Greater Cambridge Partnership submission re Cambourne to Cambridge Busway

Amongst the many documents made available by GCP is Technical Report 13 – Water Environment. There is also a 164 page document titled Appendix TR13.1: Flood Risk Assessment. In this document is Plate TR13.1-4-2 showing what is said to be the Environment Agency's Flood Map for Planning. This highlights an area of historical flooding some 200 – 300 metres upstream of the proposed Busway crossing of Bin Brook. This area contains not only my house but over 30 others in Penarth Place, Gough Way and Barton Road. A copy is shown as

Figure 1 Extract from GCP Flood Risk Assessment

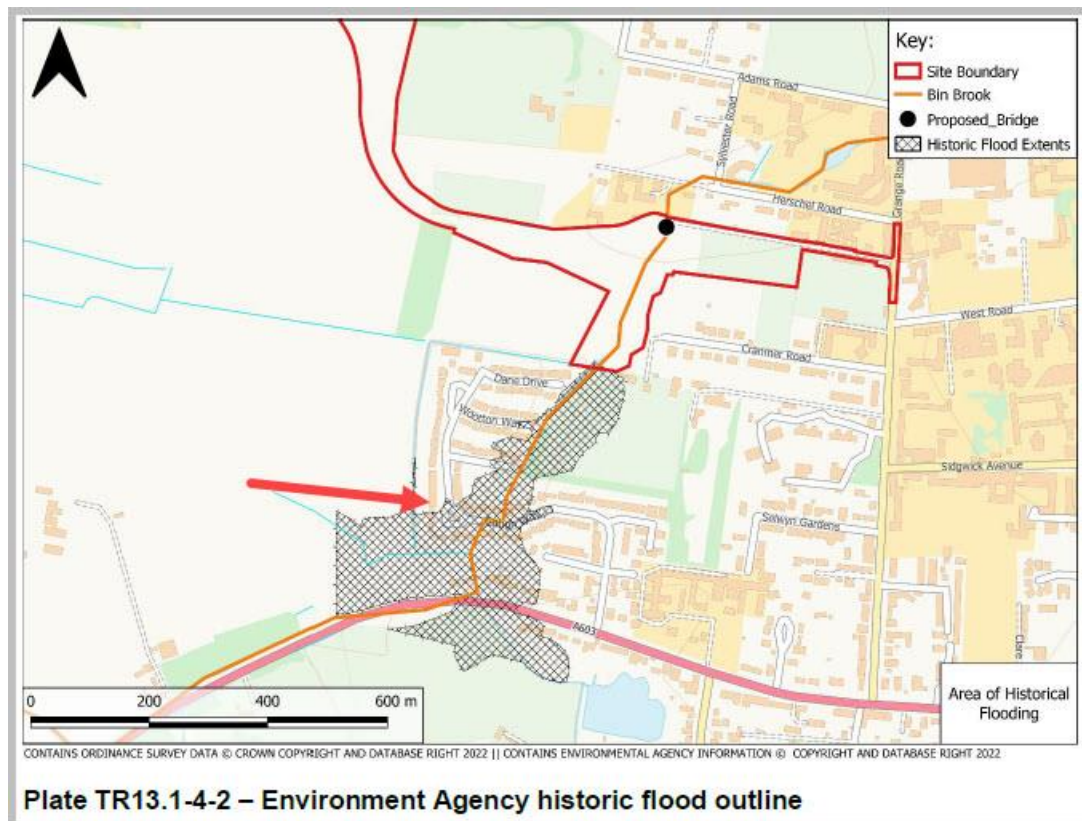
Figure 1 at the end of this letter, with the road in which I live indicated with a red arrow.

Perhaps the thoroughness with which GCP have addressed issues here can be seen by the mis-spelling of '**Ordinance Survey**' immediately below the scale at the bottom of both plates.

Figure 2 Extract from GCP Flood Risk Assessment

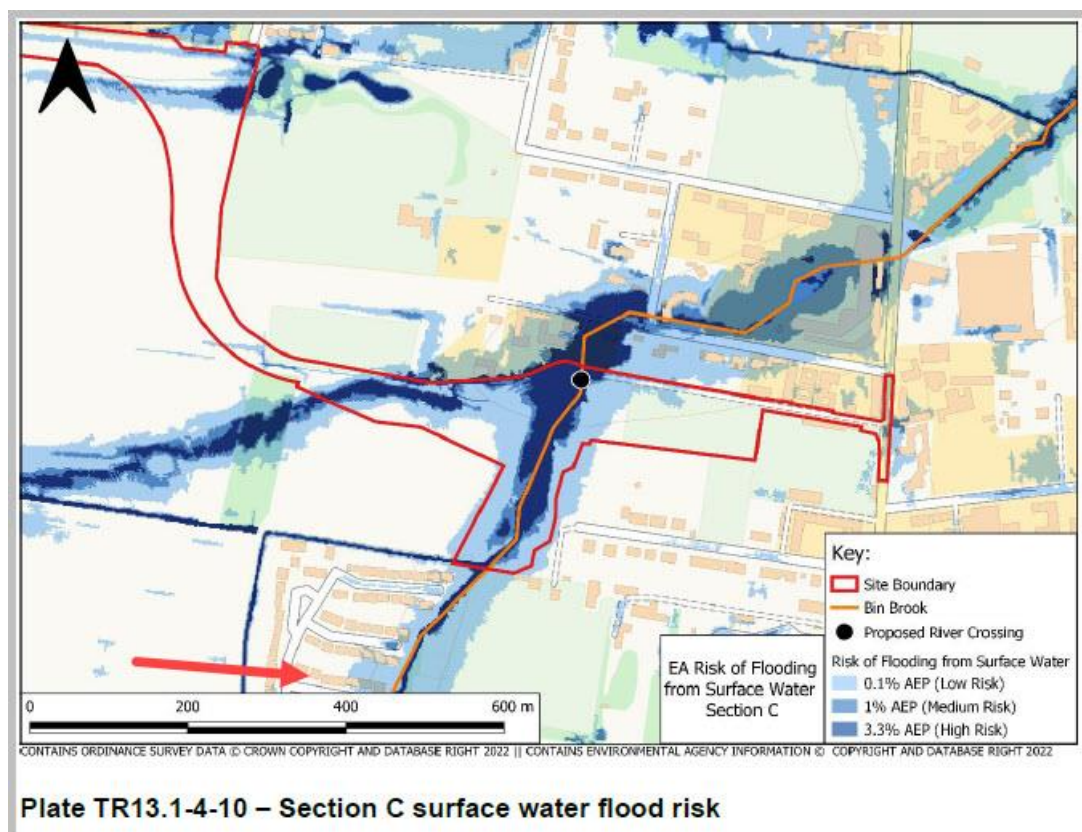
Later in this document is an illustration titled Plate TR13.1-4-10 showing the anticipated surface water flood risk in my area. A copy is shown as **Figure 2** at the end of this letter, again with the road in which I live indicated with a red arrow.

I consider it extraordinary that this plate terminates at the south with the road in which I live. How convenient that the GCP consultants have omitted the 30 or more other properties in Gough Way and Barton Road that are also potentially affected by Bin Brook flooding. It is worth noting here that Barton Road is an important arterial road (A603) which connects villages to the south west of Cambridge, as well as Junction 12 on the M11, with Cambridge. Flooding to this road could clearly have a major impact.

I am not at all convinced that appropriate estimates have been made of the impact of the proposed route and bridge across Bin Brook upon my own house and the many others in the immediate area that have conveniently been omitted from the second diagram.
